**La Jolla Shores Planned District Advisory Board (LJSPDAB)
APPLICANT PROJECT INFORMATION FORM**

- Project Tracking System (PTS) Number/Accela "PRJ" Number and Project Name (only submitted projects to the Development Services Department can be heard as action items): PRJ-1102311_____
- Address and APN(s): 8151 Calle Del Cierro, La Jolla, CA 92037 / APN: 346-344-02-00

- Project contact name, phone, e-mail: Audrey Ruland, (619) 798-4623, aruland@rulanddesigngroup.com_____
- Project description: Construction of a new attached 2-car garage with an Accessory Dwelling Unit (ADU) above.

LASKA - Garage & Accessory Dwelling Unit
 8151 Calle del Cielo, La Jolla, CA 92037
 PROPOSED FIRST FLOOR PLAN

PROPOSED SITE PLAN
 SCALE: 3/32" = 1'-0"

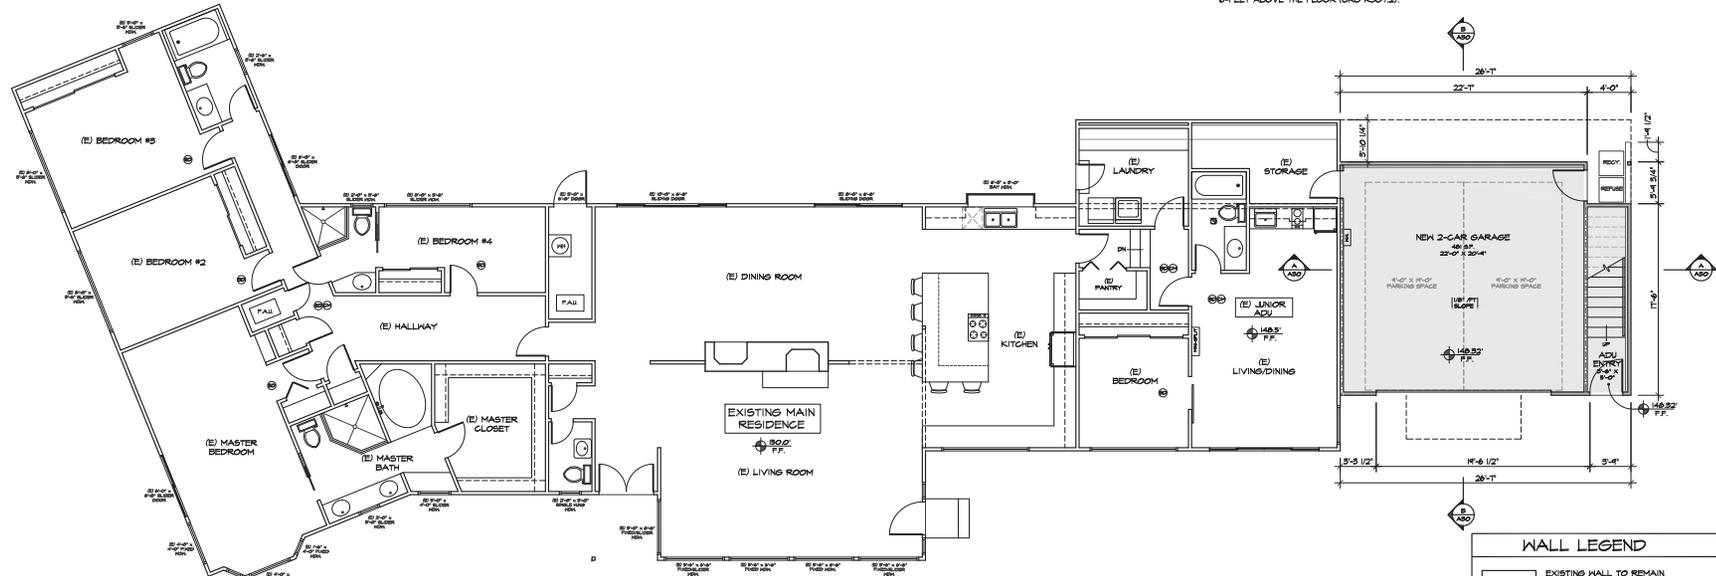
Please revise the proposed Site plan, sheet A00, to screen back the existing wood fence. Why did the fence encroach into the adjacent property? If it's not a shared fence, then it should be removed.

6. Per Building & Zoning Plat Map 250-1692, there is a 20' established front setback. Please label this as “established setback” on the site plan.
7. On the neighborhood survey site plan, please illustrate and label the 300 foot radius circle from the subject property.

8. Per 142.0340(d)(1), "Two retaining walls with a maximum height of 6 feet each are permitted in the required side and rear yard if the two retaining walls are separated by a minimum horizontal distance equal to the height of the upper wall. See Diagram 142-03H." Please revise the proposed retaining walls to comply.
